AMENDMENT DRAWING

SUPERSEDES 100-EP405T0

Drawing Title: ENLARGED ELECTRICAL ROOM C PLAN - POWER TEMPORARY

Project Title: VA PUGET SOUND HEALTH CARE SYSTEM UPGRADE SEATTLE ELECTRICAL DISTRIBUTION FROM 5kV TO 15kV

Drawing Title: MCC ELEVATIONS

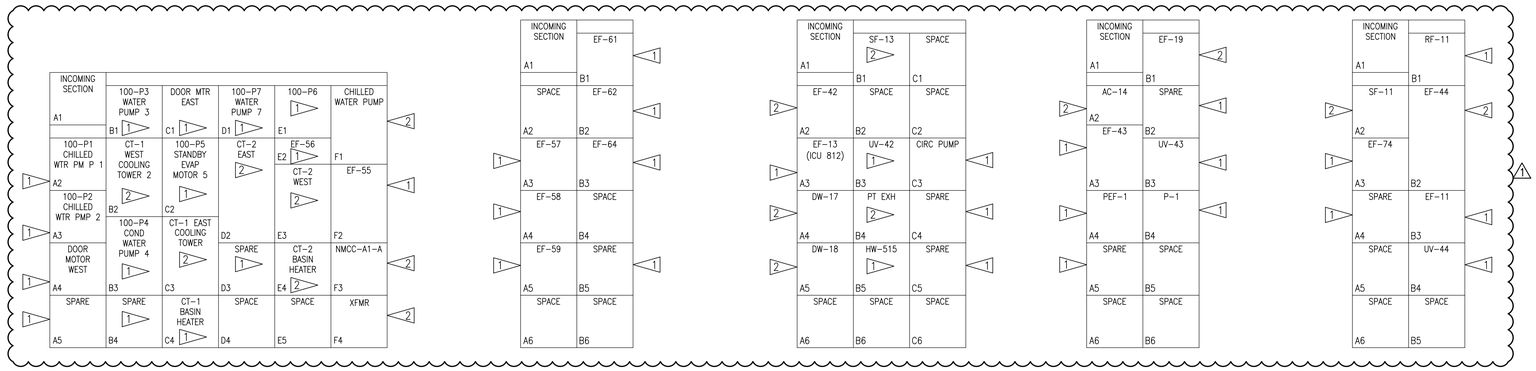
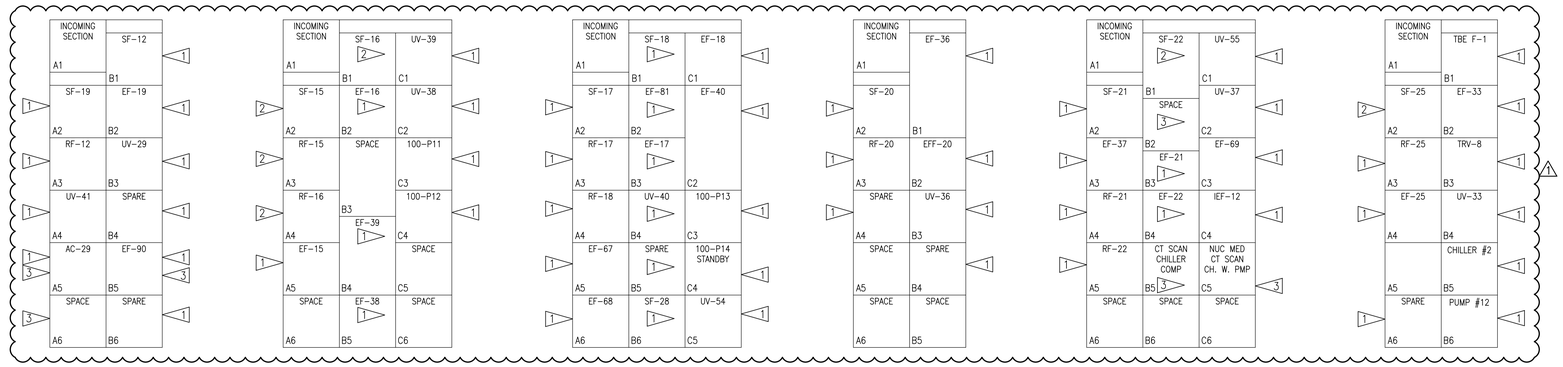
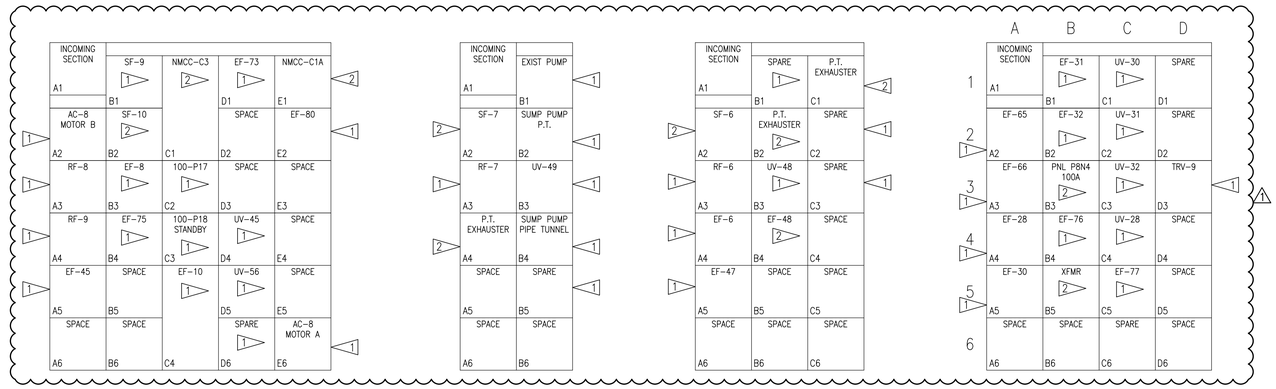
1. REFER TO MCC SCHEDULES ON DRAWINGS 100-EP801, 100-EP802 AND 100-EP803 FOR ADDITIONAL WORK.
2. COORDINATE SHUT DOWN OF ALL EQUIPMENT WITH OWNERS' REPRESENTATIVE PRIOR TO START OF WORK.
3. RECONNECT ALL BRANCH FEEDERS AND CONTROL WIRING.
4. PROVIDE LABELS ON NEW BUCKET SWITCH ENCLOSURES.

1. REPLACE EXISTING BUCKET WITH NEW CONSISTING OF CIRCUIT BREAKER, STARTER, OVERLOAD RELAYS, PILOT LIGHTS, HOA SWITCH, OPERATING HANDLE, CONTROL POWER TRANSFORMER, RESET BUTTON AND ALL APPURTENANCES TO PROVIDE A COMPLETE AND WORKING BUCKET SWITCH.
2. REPLACE EXISTING BUCKET WITH NEW CONSISTING OF CIRCUIT BREAKER AND OPERATING HANDLE.
3. FIELD VERIFY EQUIPMENT SERVED. REDLINE AS-BUILT DRAWINGS AND RETURN TO VA, RESIDENT ENGINEER (RE).
